Site Design for a Hotel on Pantops, Charlottesville

A Technical Report submitted to the Department of Civil & Environmental Engineering

The Site Design for a Hotel on Pantops, Charlottesville Final Report

REVISION DESCRIPTION	DATE	DATE	DESIGNED BY	CHECKED BY	SCALE
		2/28/2024			1" = 20'
PANTOPS HOTEL ALBEMARLE COUNTY, VA UTILITY PLAN					
JOB NO. _____					
SHEET NO. 6

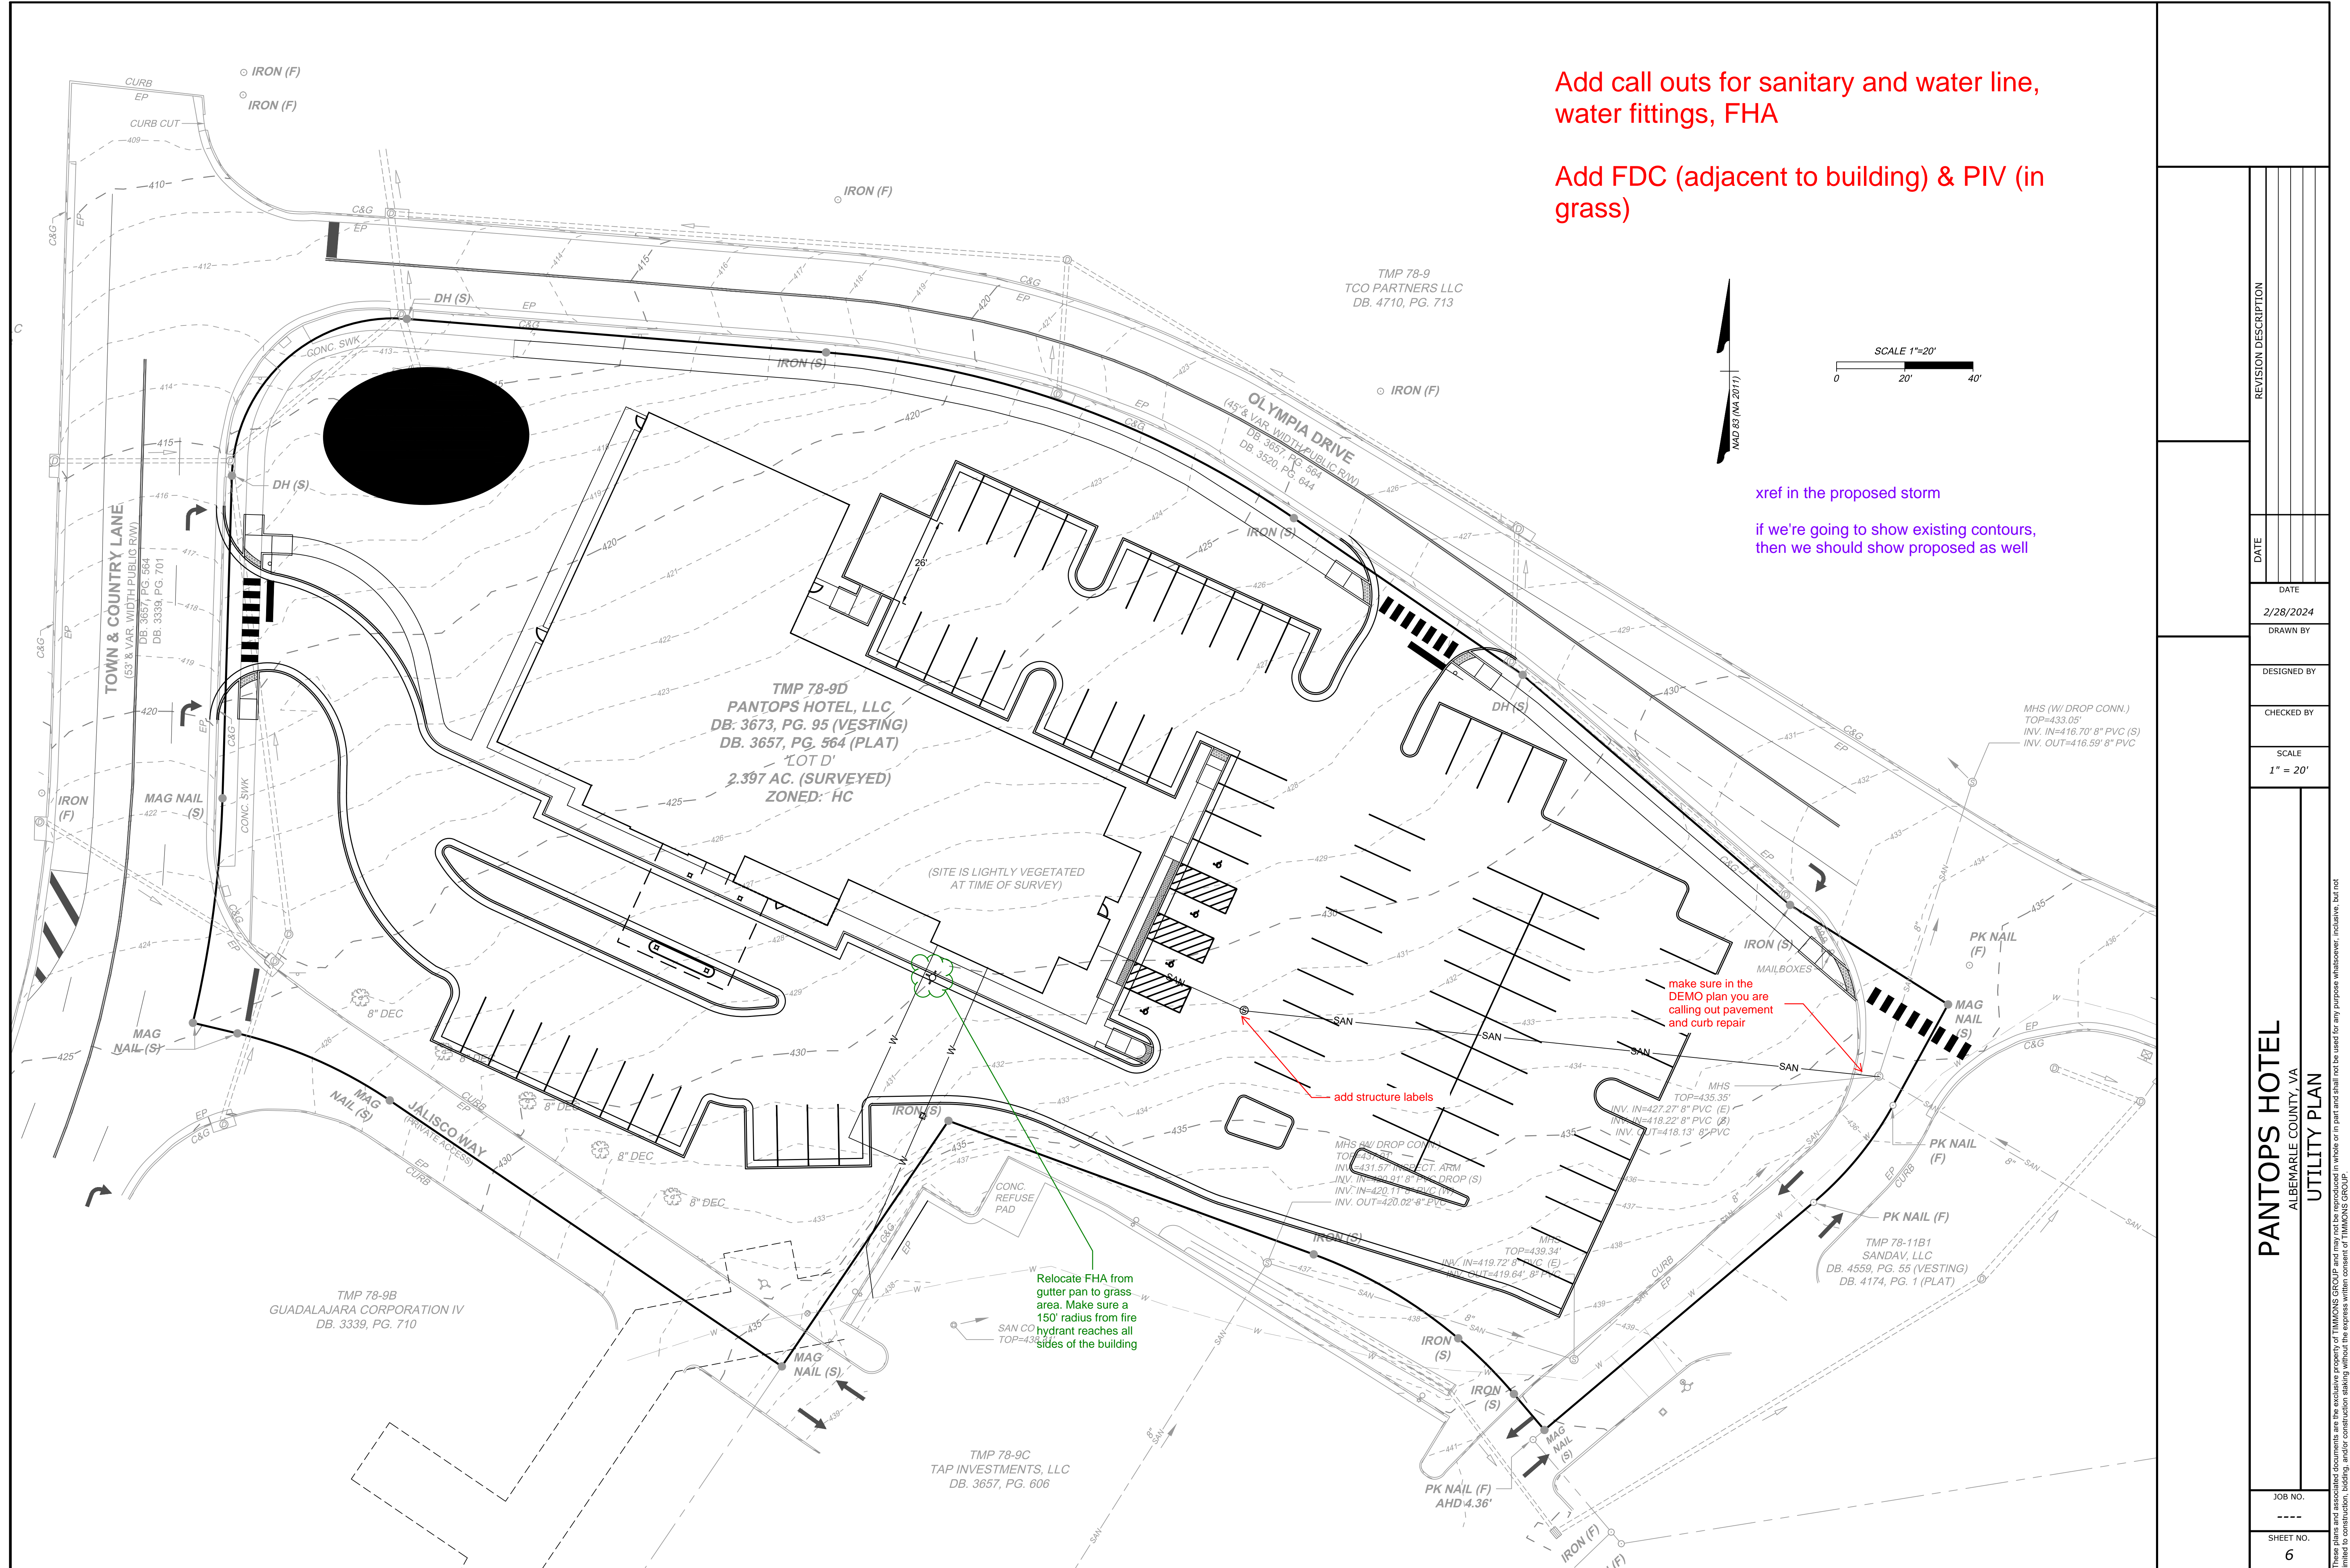
Add call outs for sanitary and water line, water fittings, FHA
